PIERCE STREET PARK CONSTRUCTION PROJECT
CONTRACT NO. C15-1
CITY OF ALBANY, CA
ADDENDUM NO. 3 – November 4, 2016

RE: Geotechnical Plan Review Comments
Pierce Street Park
Albany, California

FILL SLOPE DETAILS

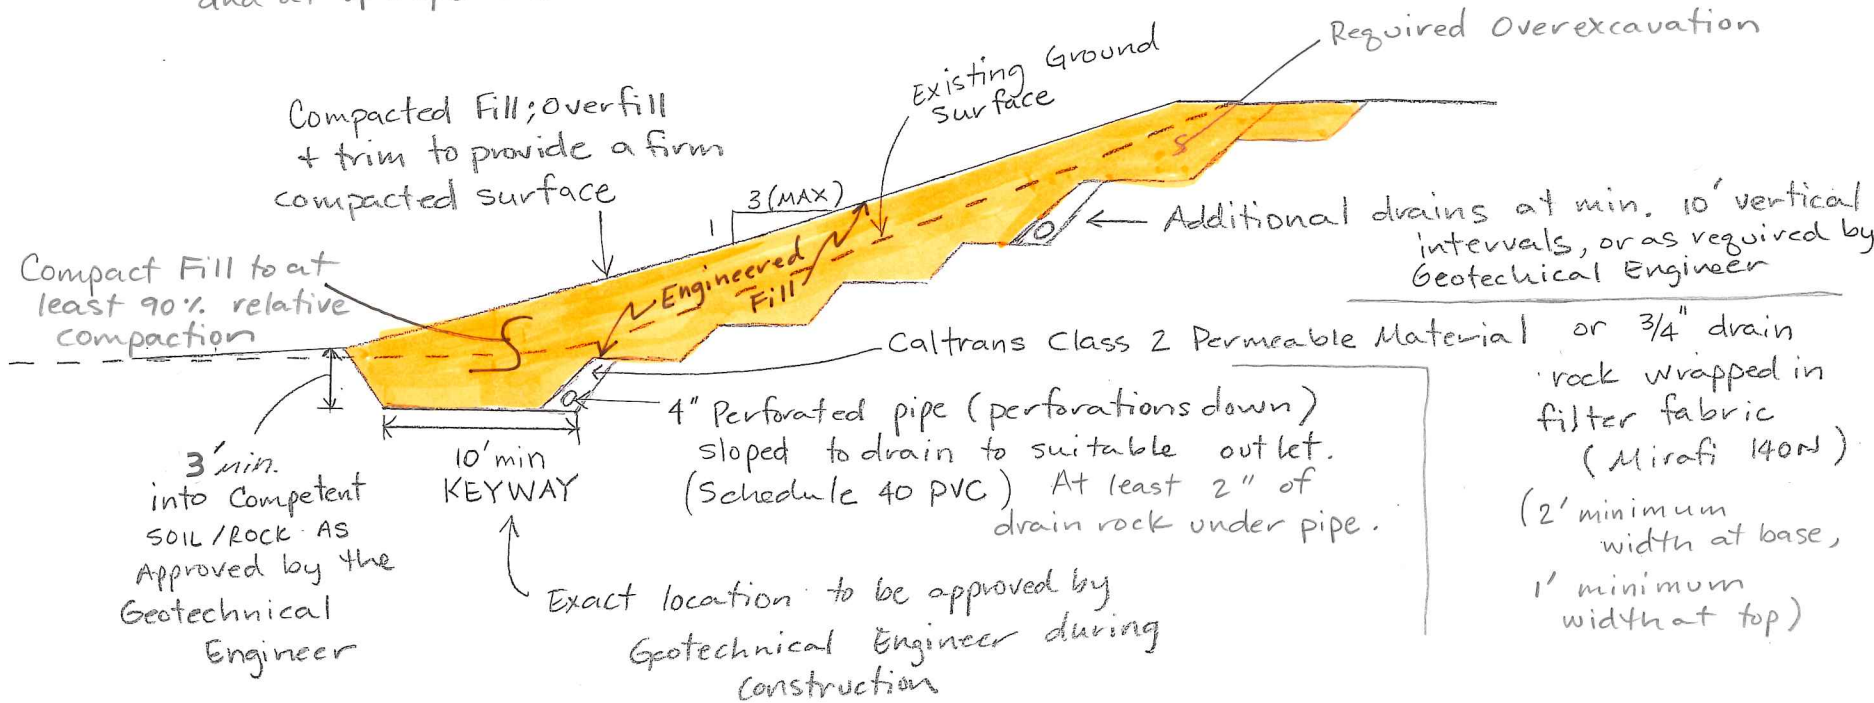
- We recommend including additional detail regarding fill slope construction. Our recommendations are presented on Plate 1 (attached).

Notes: 1. Keyway Excavation and subdrain installation should be observed by the Geotechnical Engineer.

2. Where existing slope exceeds 5:1 (horizontal to vertical) excavate series of benches in competent soil/rock approved by the Geotechnical Engineer.

3. All subdrains should have cleanouts at a min. of 200' intervals and at upslope end.
